Board of Architectural Review

DATE: January 15, 2020
TO: Board of Architectural Review Chair and Members
THROUGH: Jason Sutphin, Community Development Division Chief *JDS*
FROM: Tommy Scibilia, BAR Liaison *TS*
SUBJECT: **Brown's Mazda – Work Session**

1. Case Number: BAR-19-00788
2. Address: 10570 Fairfax Boulevard, tax map parcels 57-2-02-009 and 57-2-02-010
3. Request: Car dealership redevelopment and site improvements
4. Applicant: Gordon Riddle
5. Applicant's Representative: John L. McBride
6. Status of Representative: Agent
7. Zoning: CR Commercial Retail, Architectural Control Overlay District

CONCEPTUAL LANDSCAPE PLAN
 SPECIAL USE PLAN
BROWN'S FAIRFAX MAZDA
 CITY OF FAIRFAX, VIRGINIA

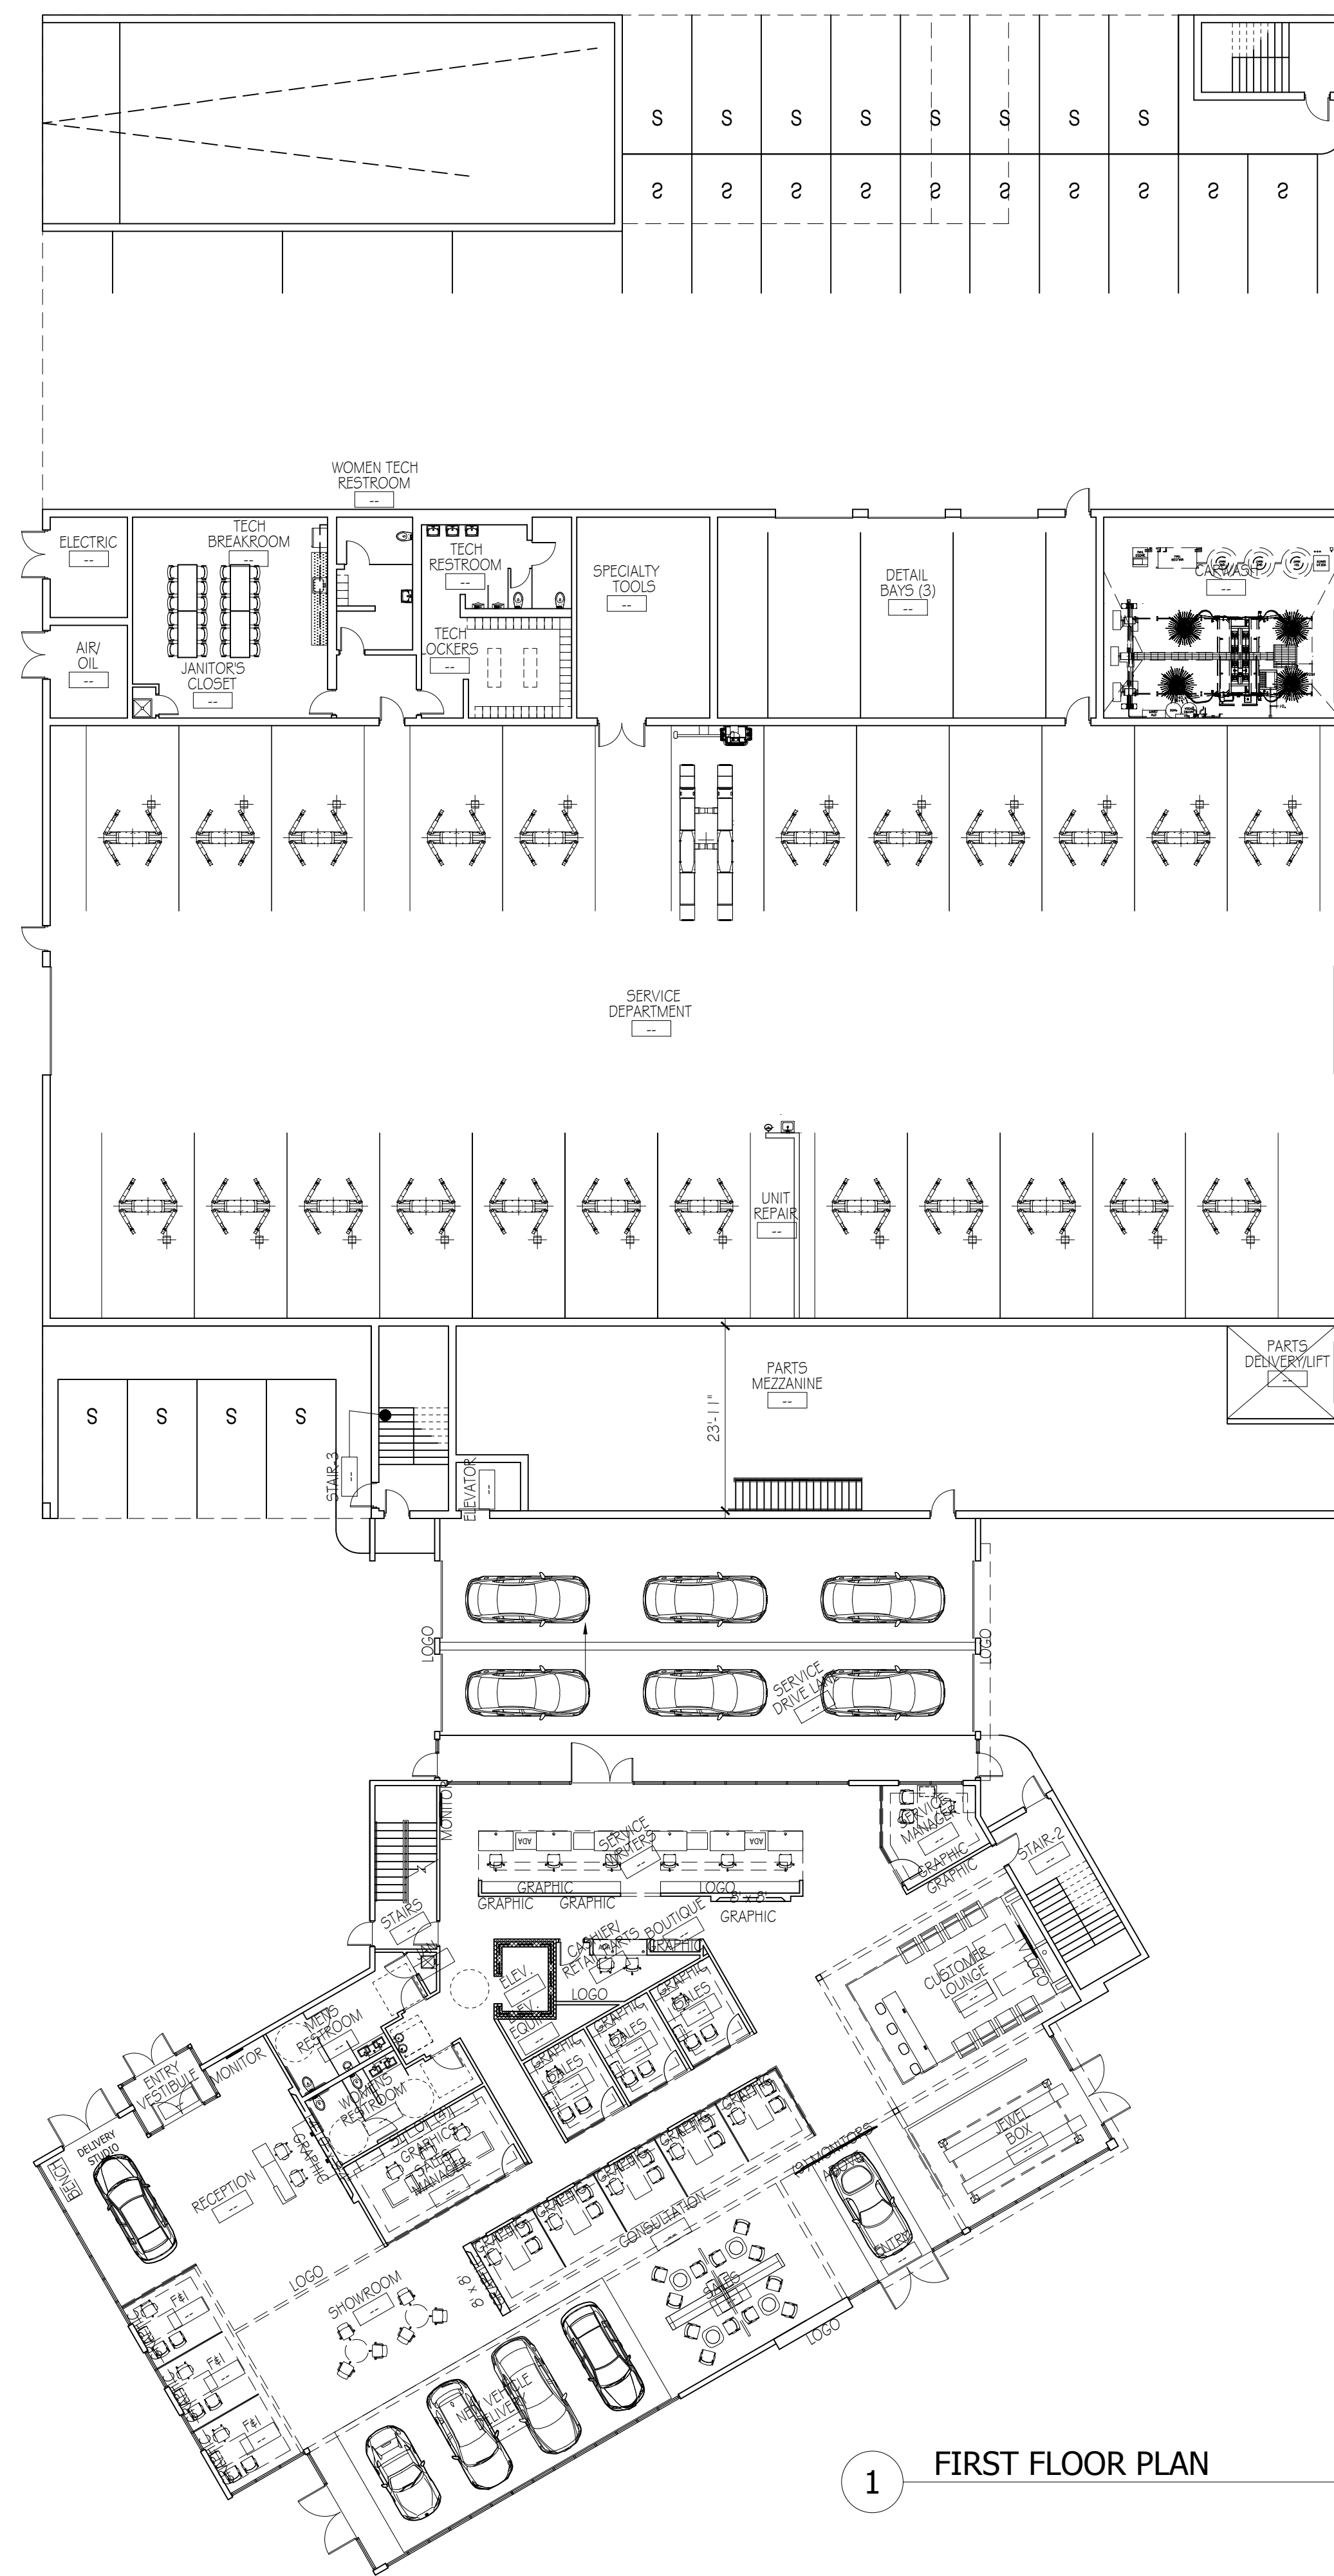
The preliminary landscape plan shows canopy trees and shrubs in key locations throughout the site. Canopy trees are proposed along Fairfax Boulevard inside the sidewalk, on the east side of the entrance drive, and in various landscape islands within and around the surface parking areas. Shrubs are shown along the east and west peripheries of the surface parking areas around the main building, and along the periphery of the surface parking area in the southwest portion of the site. No species are called out in this preliminary plan.

2 FRONT (SOUTH) ELEVATION
Scale: 1:20

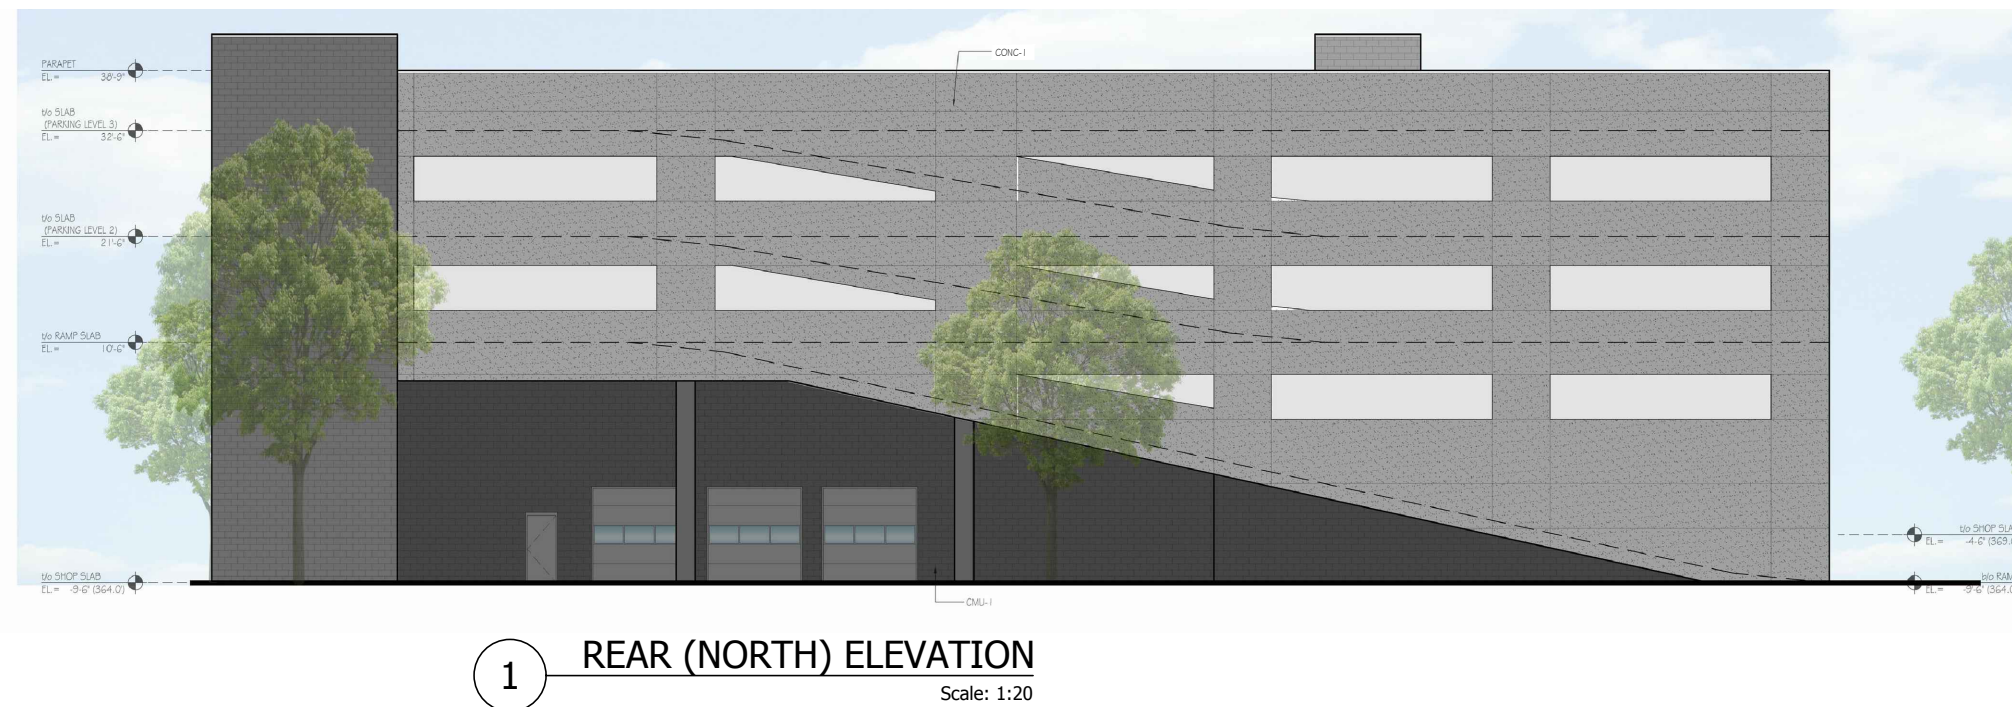
Explore varying the roofline. A constant roofline gives the effect of a large box.

Incorporate masonry into the design of the front of the building. EIFS seems to be the dominant wall material aside from metal panel, but we typically encourage this be used on less visible areas of buildings.
